ENVIRONMENT CANADA
CONSERVATION AND PROTECTION
ENVIRONMENTAL PROTECTION
PACIFIC AND YUKON REGION

STUDY OF PEDDER BAY:
DND ROCKY POINT, DOJ WILLIAM HEAD INSTITUTION,
LESTER B. PEARSON COLLEGE AND PEDDER BAY TRAILER PARK
OCTOBER-NOVEMBER 1986

Regional Program Report 87-04

FIGURE 3 DND ROCKY POINT LAGOON

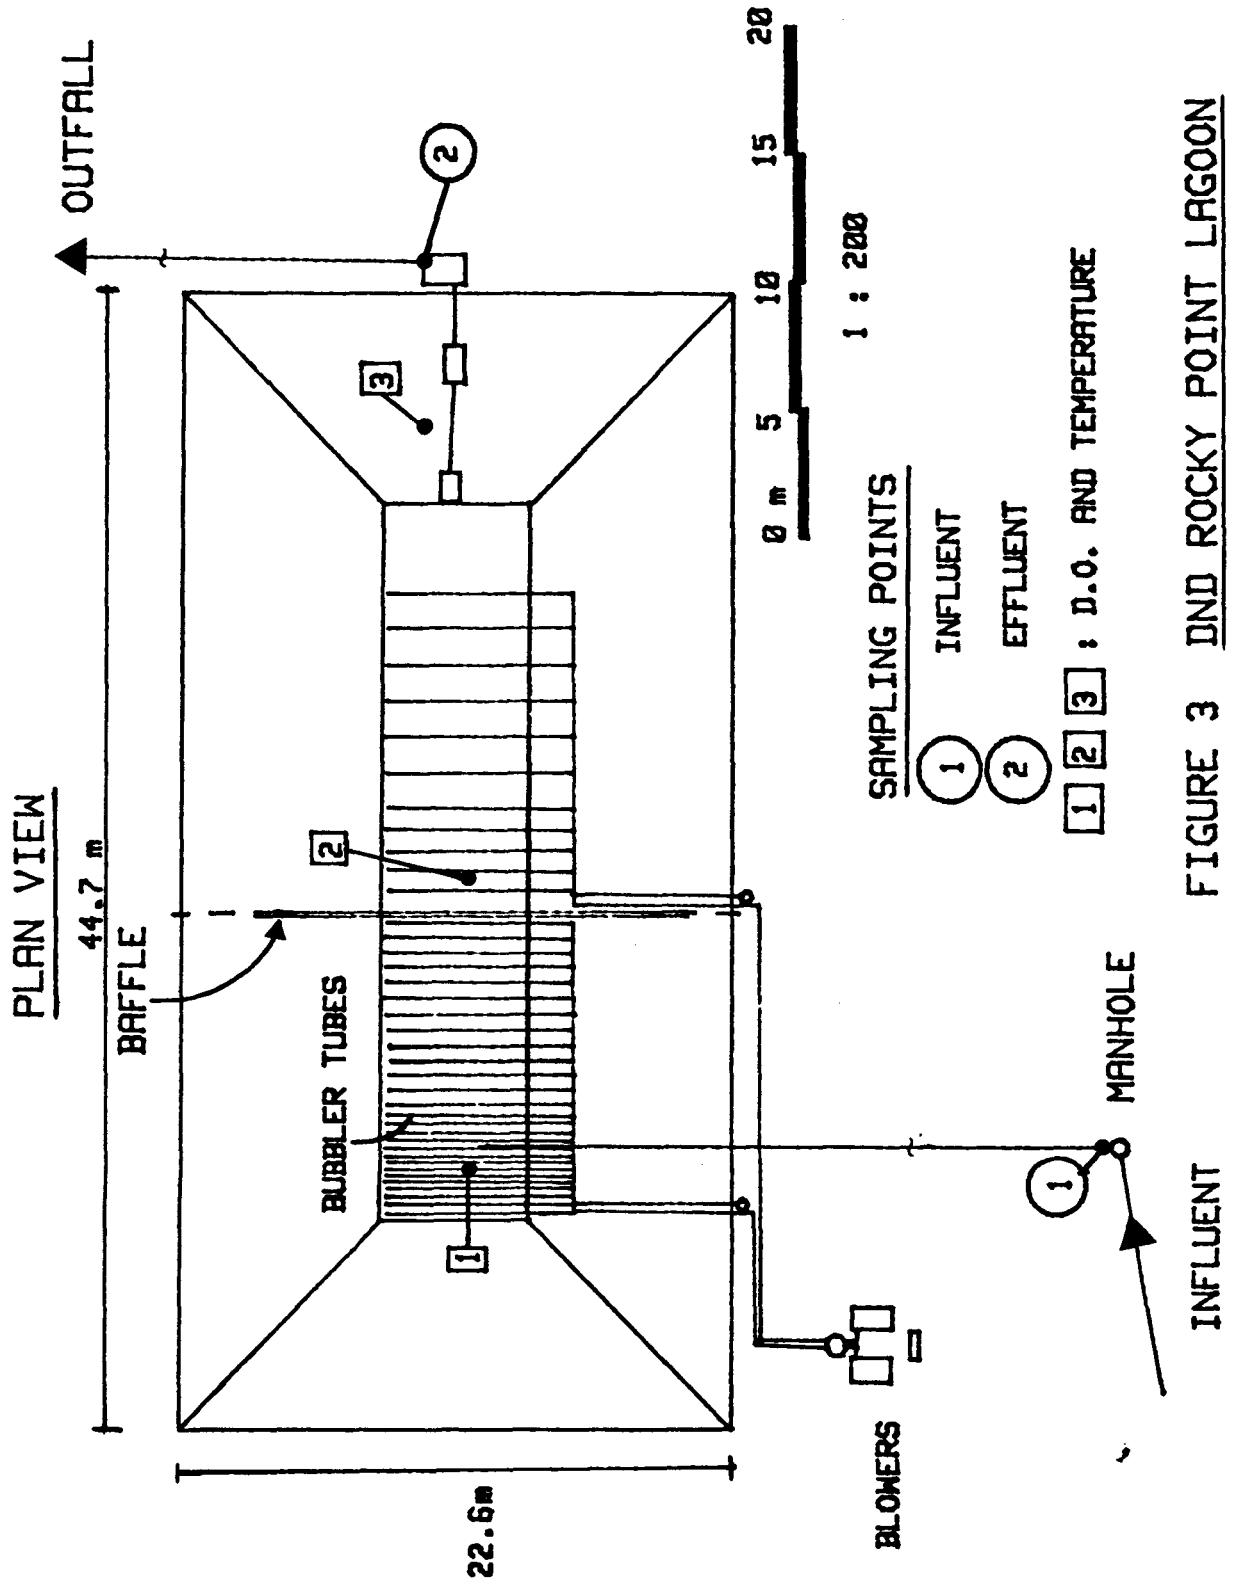
The distance separating the last bubbler tube and the final effluent outlet is about 9 m. This distance is insufficient to allow suspended solids to settle effectively.

3. The final effluent was not toxic to fish.
4. Under the aerated mode, too much aeration was provided leading to poor settling and waste of energy.
5. The use of both aeration systems in the first and second section of the lagoon did not allow enough settling to remove the solids. BOD was not reduced to lower values because of high solid levels in the final effluent.
6. This new lagoon system effluent quality can be improved with a minimum changes.

1. Aeration should be used only on the first side of the lagoon prior to the baffle leaving the second portion for settling.
2. Monthly final effluent monitoring for BOD and NFR should be conducted under the modified conditions to determine the optimum treatment level.
3. A flowmeter device should be installed on the final effluent.

FIGURE 4 WILLIAM HEAD INSTITUTION - SCHEMATIC OF SEWAGE TREATMENT PLANT

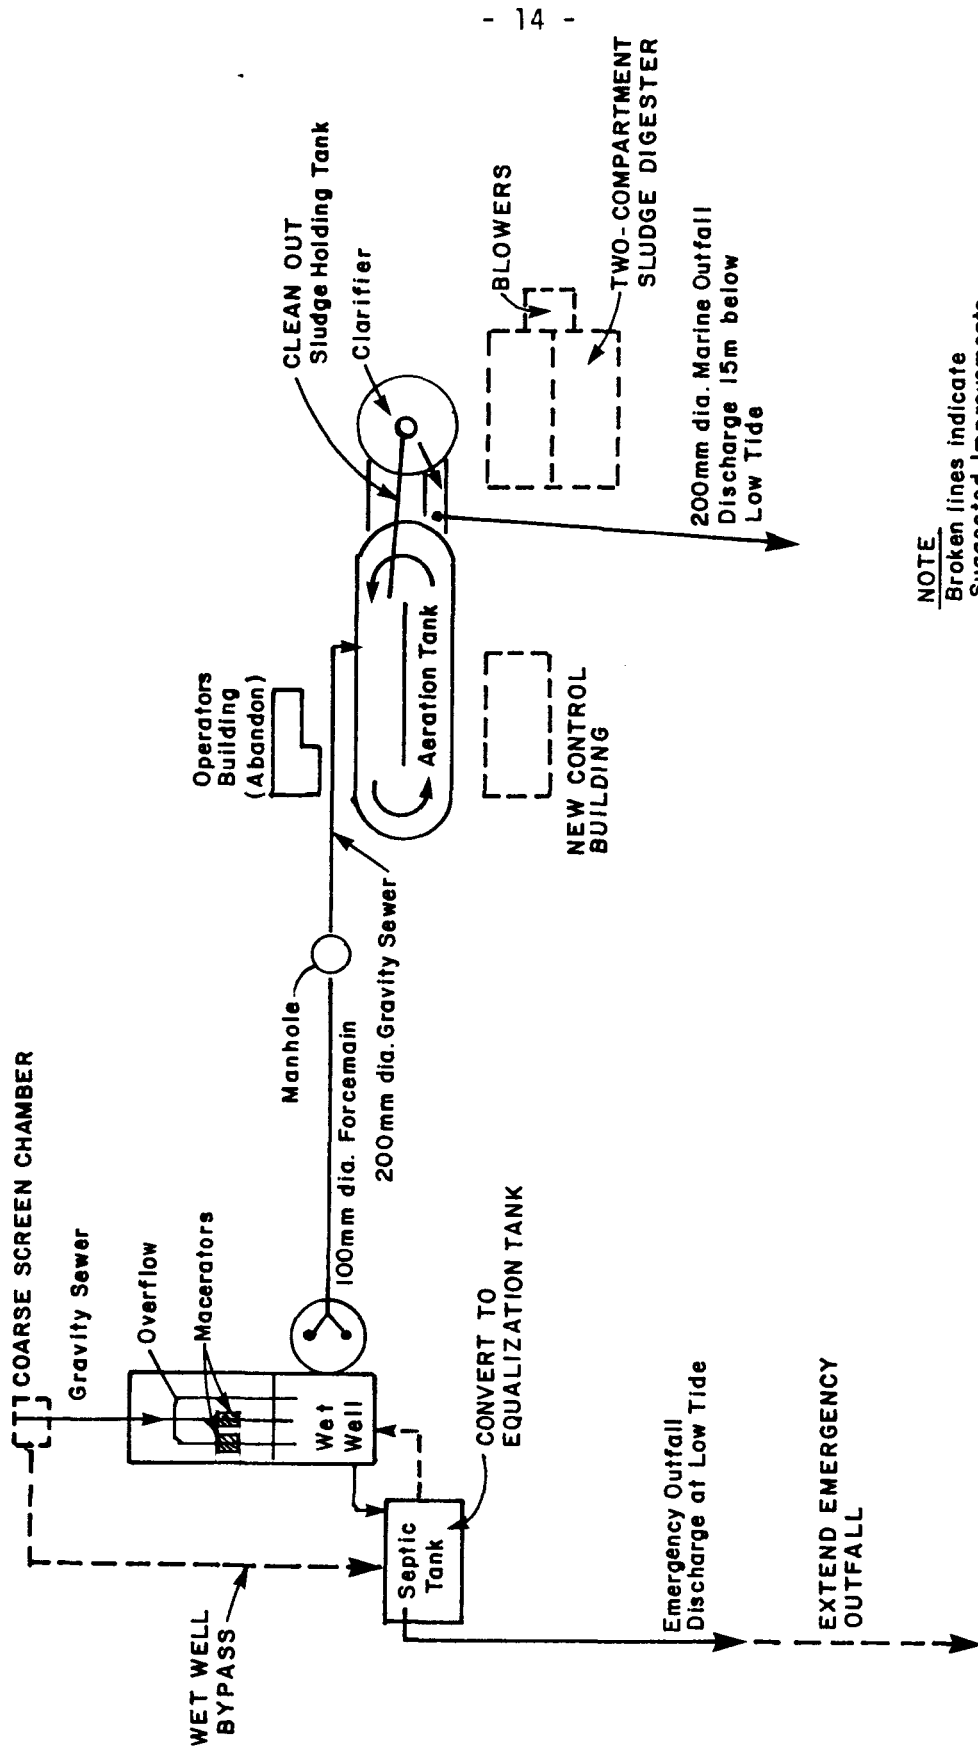
The clarified effluent flows to the chlorine contact chamber which has not been used for chlorination for several years. A V-notch weir allows flow measurement. The present flowmeter is unreliable and was not in working condition during the survey.

The average flow through the plant during the survey was 225 cu·m/d (49500 Imp·gpd). Table 11 shows the treatment plant characteristics compared to typical values for extended aeration. Undersizing of the aeration tank is shown by the short detention time and the high F/M ratio. High F/M ratios can result in dispersed bacterial growth which will not settle properly. The oxygen levels in the aeration tank were kept in an appropriate range (greater than 1 mg/l). According to the consultant's report monitoring, the D.O. in the aeration tank cannot be kept over 1.0 mg/l at all times with the aeration system used. Temperature and solids level influence D.O. level. Lower D.O.'s could create odor problems and reduce plant efficiency.

The consultant presents a good overview of the operation. Recommendations were made (Appendix I). The following comments are made indicating the works priority.

1. A reliable flowmeter should be installed to measure total flow through the plant and to monitor progress with the sewer rehabilitation program.
2. The discharge from the Works Office to Parry Bay and other direct discharges should be directed to the sewage treatment plant.

3. A comprehensive sewer rehabilitation (item 9) should be the prime consideration. The aeration tank, close to design capacity, is the limiting flow element. Any increase in capacity would be expensive. Therefore, flow reduction is primordial.

4. The installation of a coarse screen upstream of the pump station macerators (item 1) would reduce repair costs.
5. The pump station and flow equalization package (items 2, 3 and 4) consisting of the construction of a wet well bypass line, the conversion of the septic tank into an equalization tank and replacement of one of the two pumps at the lift station, should be implemented next. It would facilitate servicing in the wet well and maintain a more constant flow to the aeration tank.

6. Sludge digestion and construction of a new control building (items 6, 7 and 8) should be next on the priority list. Extra aeration from the new air blowers in the digesters could be used to maintain sufficient dissolved oxygen levels in the aeration tank all year around. Drying beds construction should be included in the overall planning. The main benefits would be: 1) elimination of sludge hauling costs, 2) beneficial use of the sludge as a soil amendment or fertilizer product, and 3) independence from CRD policies regarding sludge disposal to the sewer system.
7. Extension of the shallow emergency outfall would come last on the priority list. Overflows would occur rarely thanks to the improvements to the system and the general maintenance program.

1. The flowmeter at the V-notch weir should be replaced or fixed.
2. The recommendations listed in the consultant's report should be implemented in the order described in Section 2 of this report as money is made available.

3. Drying beds should be included in the overall project.
4. All the wastewater should be directed to the sewage treatment plant.
5. The operator should be certified under the British Columbia Water and Waste Association operators' certification system.
